Tesla, Inc.
Service Bulletin

***Inspect Hood Latch Actuator Connector
for Swapped Electrical Wires***

SB-20-17-006
June 5, 2020

Figure 1

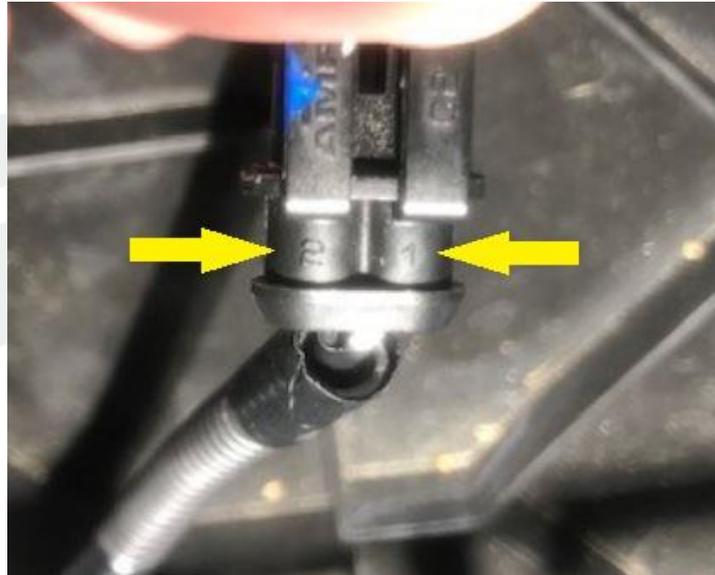
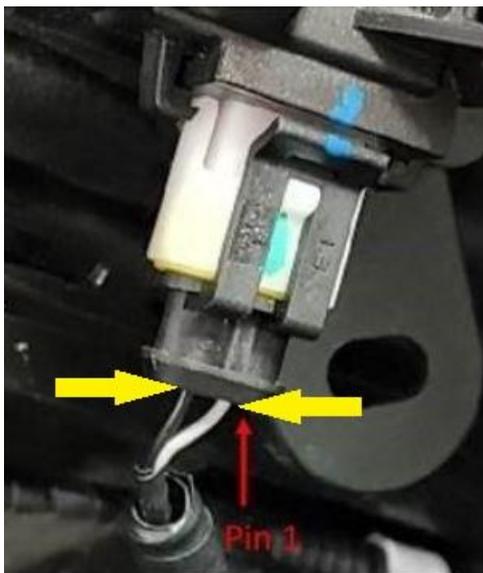
**NOTE:** The connector barrels are labeled with the numbers “1” and “2” (Figure 1). The white wire should be in barrel 1 and the black wire should be in barrel 2.

Figure 11

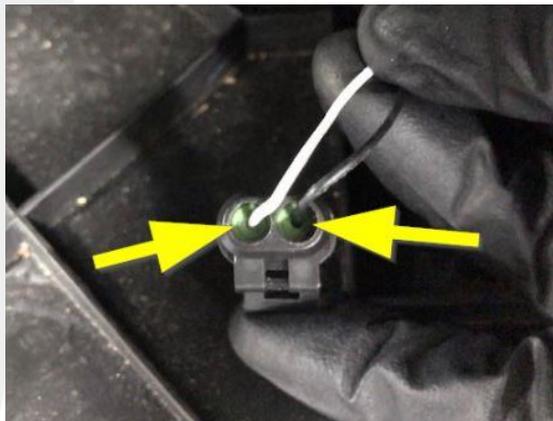
NOTE: Ensure the terminal pin seals are fully seated in the connector housing (Figure 11).
